NORTH CENTRAL HIGH SCHOOL, PHASE 2

Addendum 2

CC-01

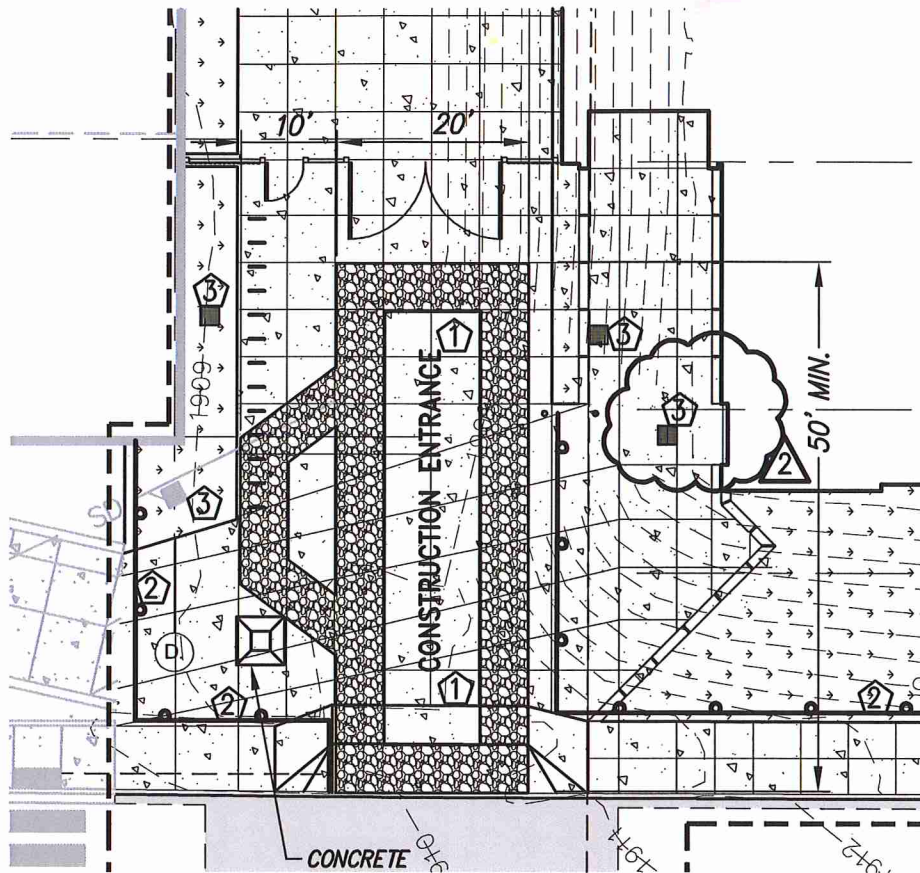
SHEET C1.10, EROSION CONTROL PLAN:

ADD: New catch basin near Grid Line N at northwest corner of new building and label with Reference Note #3.

CC-03

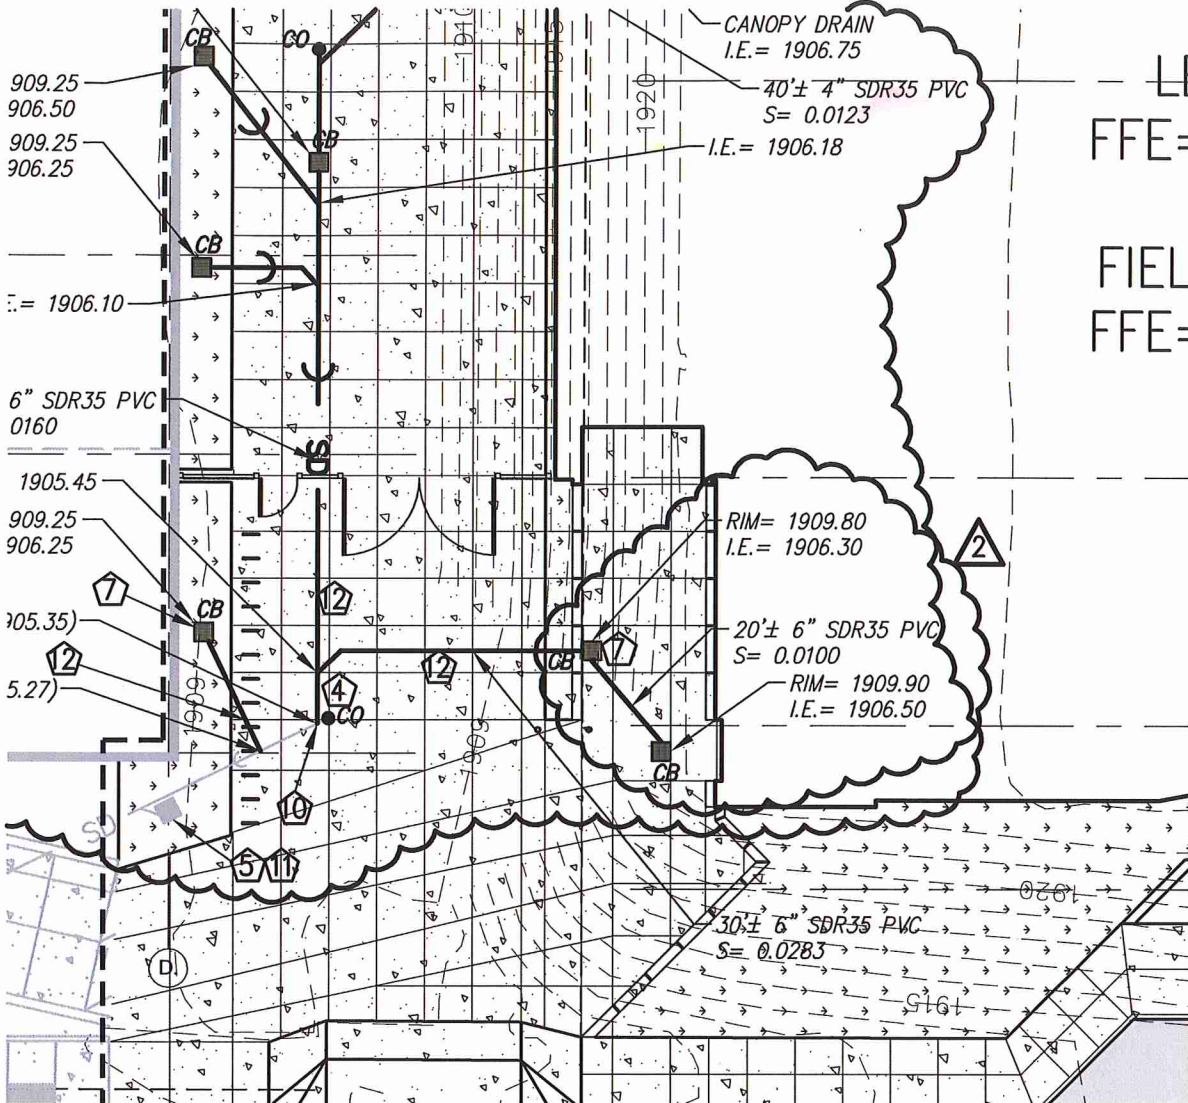
SHEET C1.30, STORM WATER PLAN:

ADD: New catch basin near Grid Line N at northwest corner of new building and label with Reference Note #7.

ADD: +/-20' of new 6" PVC storm drain pipe from new catch basin near Grid Line N at northwest corner of new building to nearest proposed catch basin.

CA-05

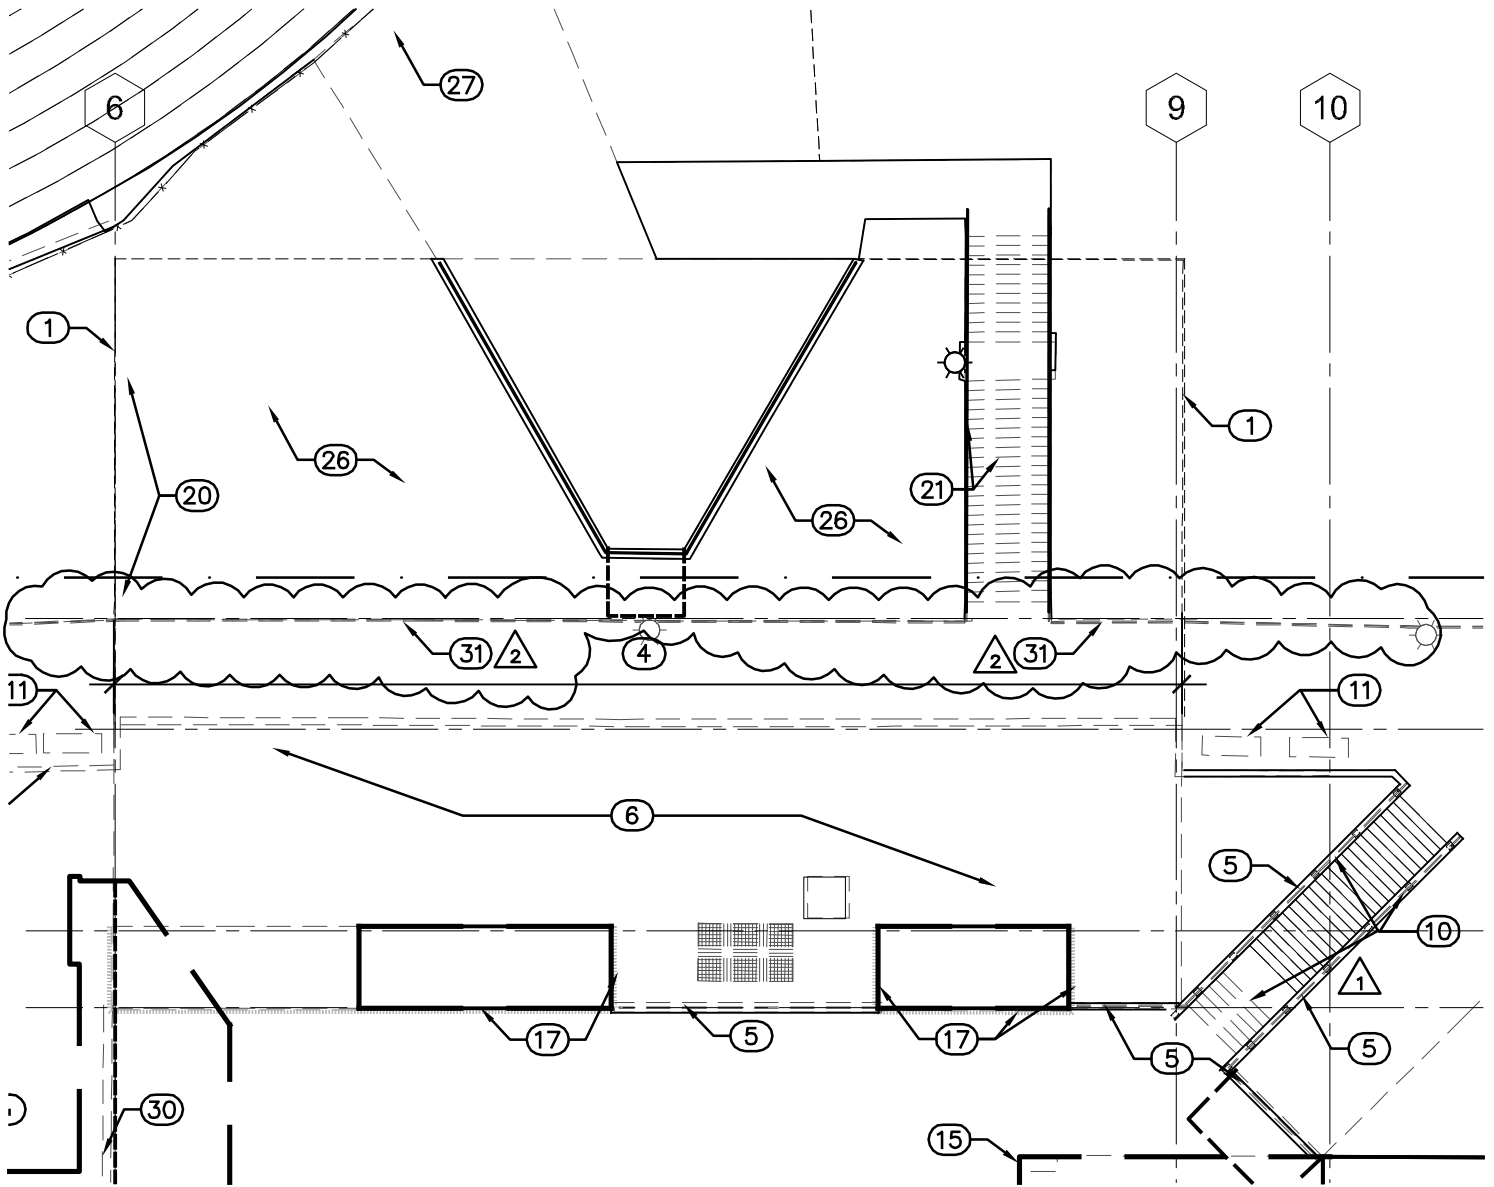
SHEET A1.01, SITE DEMOLITION PLAN:

CHANGE: Coded note 5 at existing railing along east walk to new coded note 31 as shown on the attached clarification drawing CA-05.

(31) SALVAGE & STORE EXIST RAIL ALONG WALK, REPAIR/STRAIGHTEN NORTH END, PRIME, PT & REINSTALL.

CA-06
 RE: 1-A2.02
 ADDENDUM 2

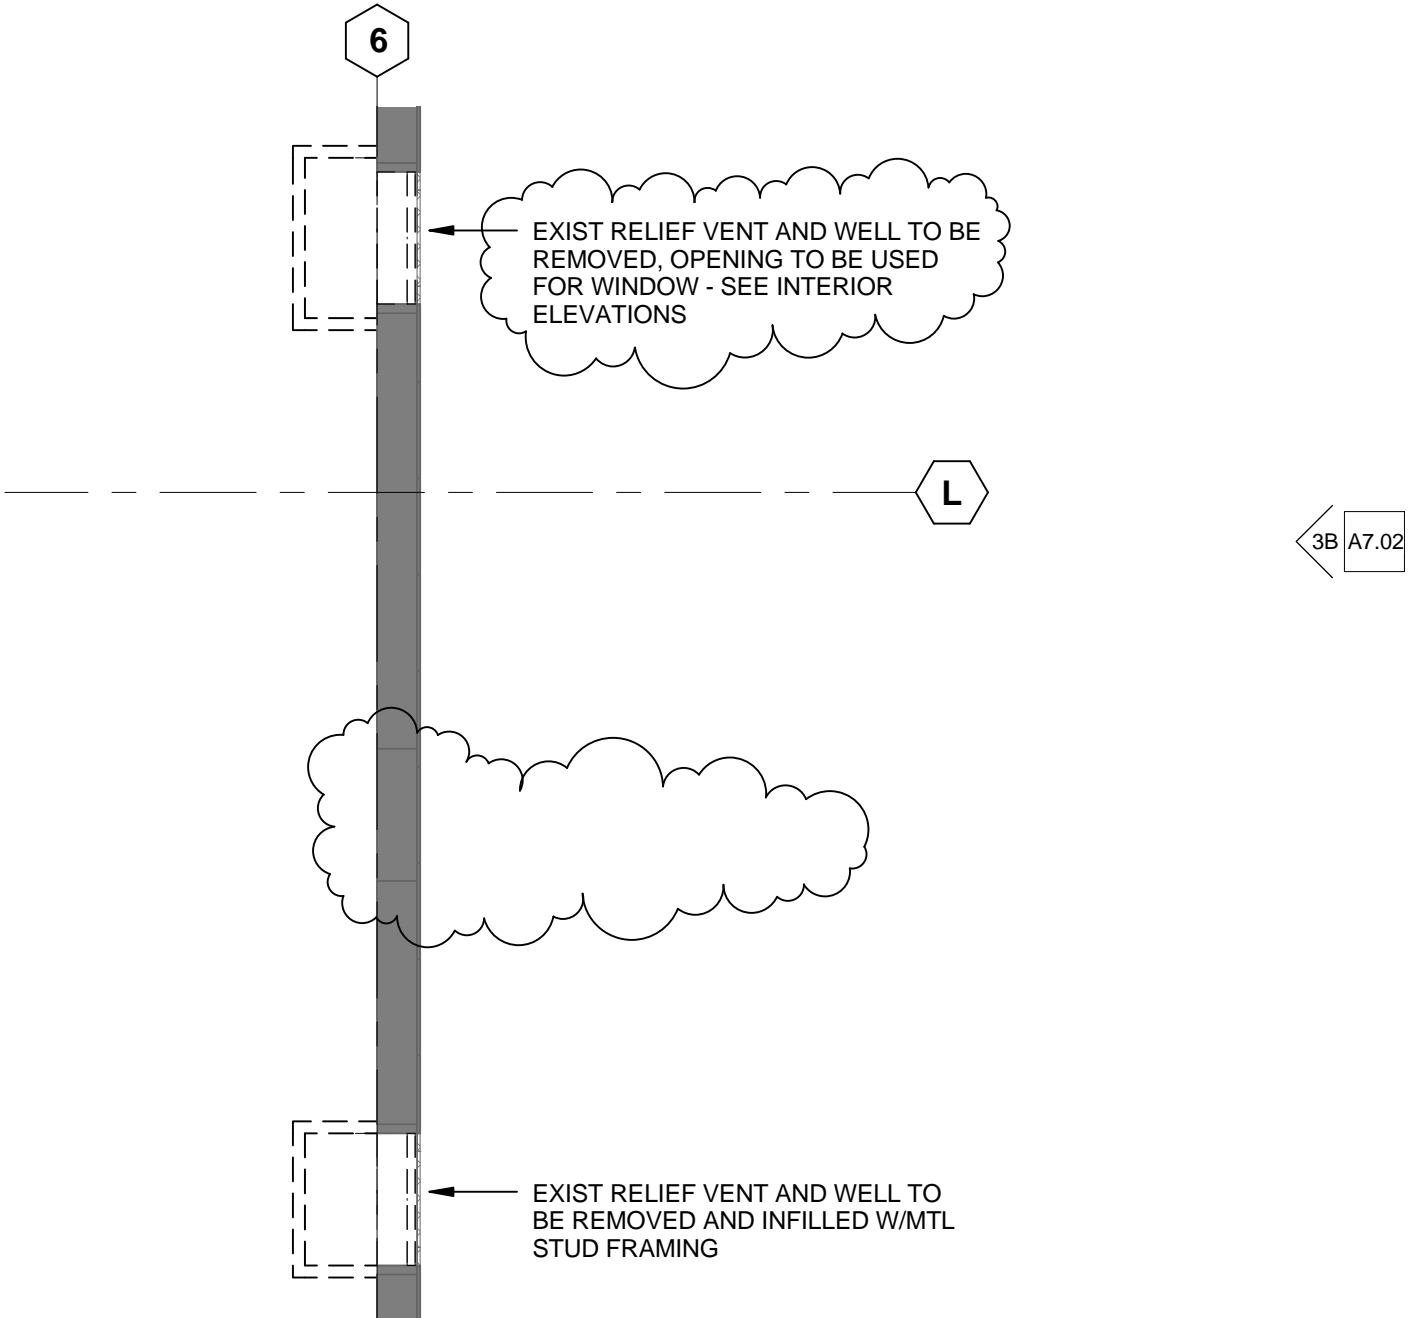
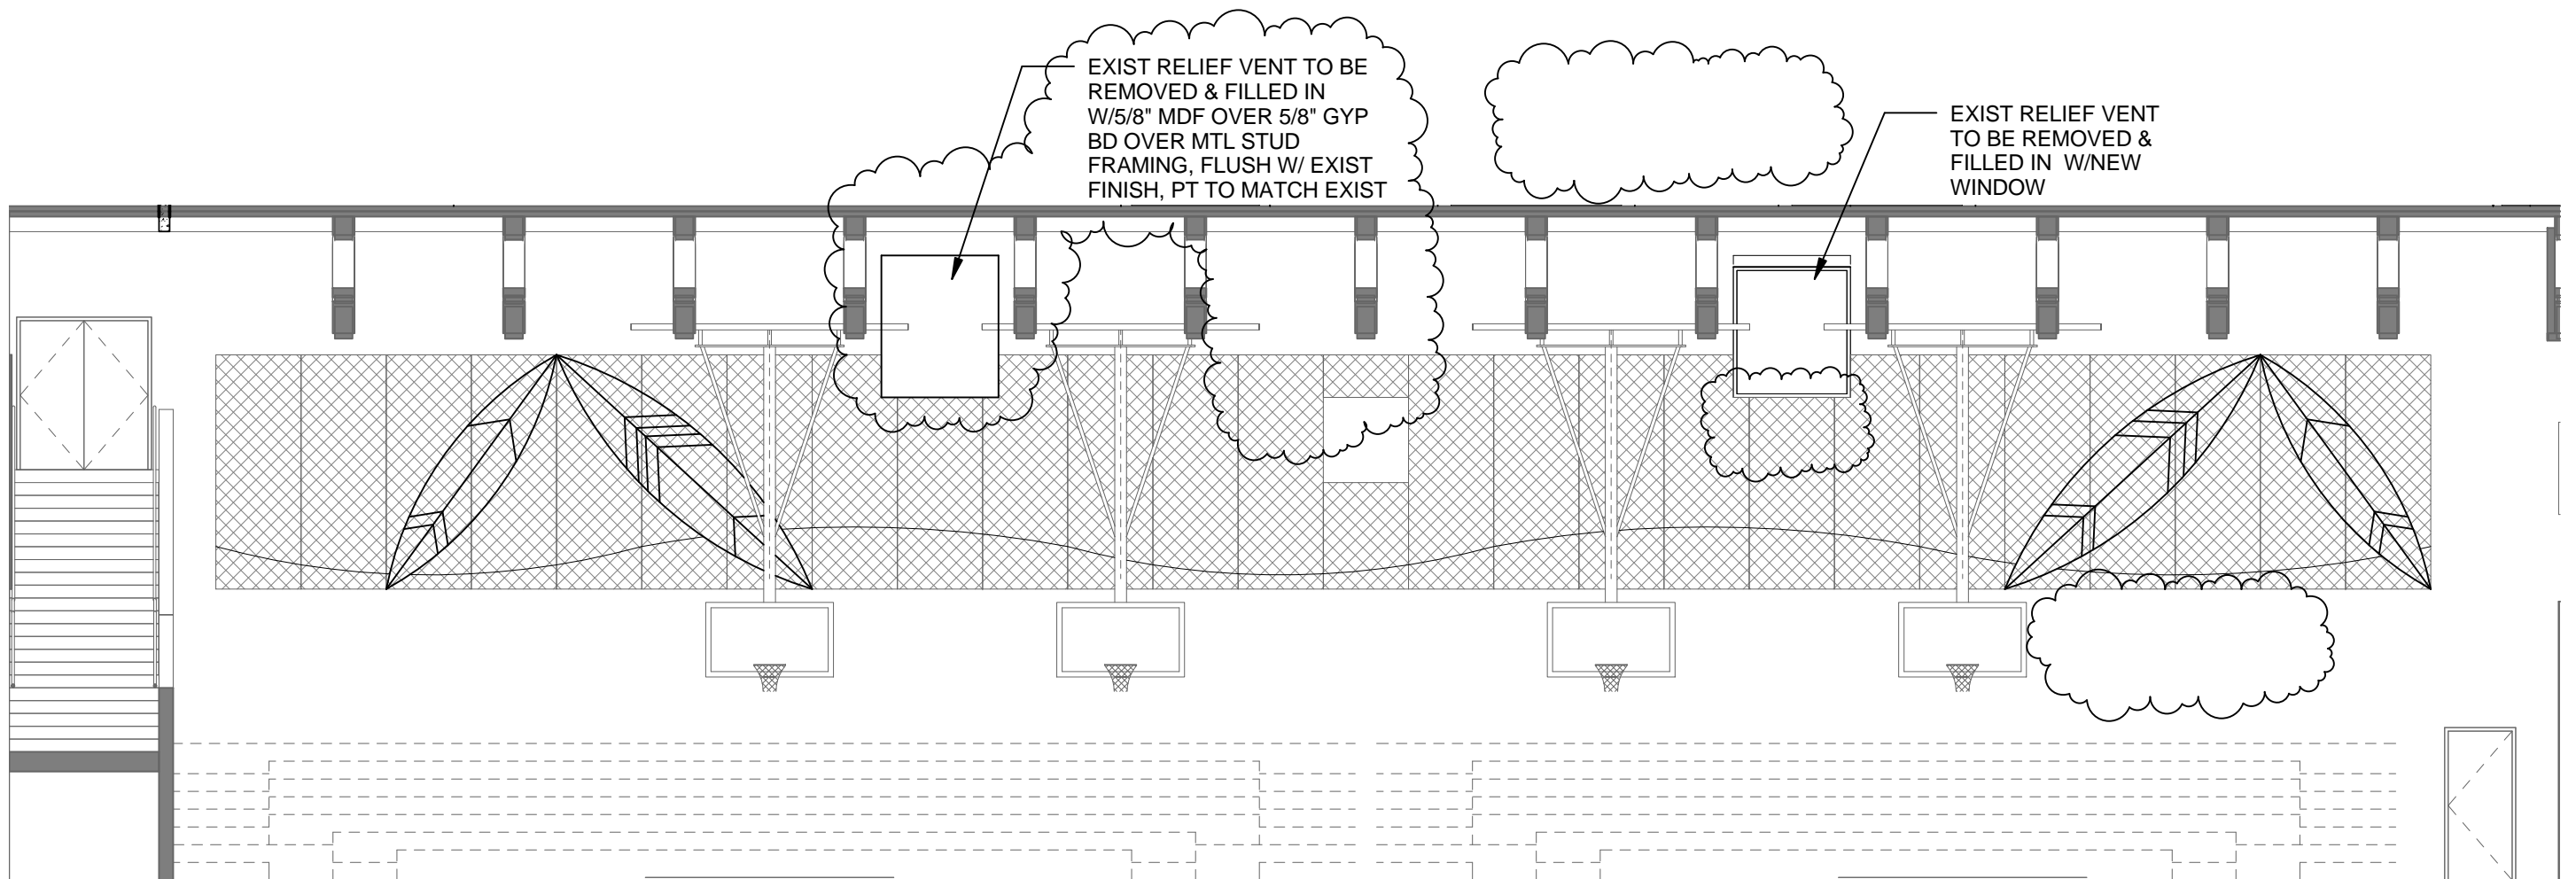
SHEET A2.02, LEVEL 1 DEMOLITION PLAN:

CHANGE: Along Grid 6 as shown on the attached clarification drawing CA-06.
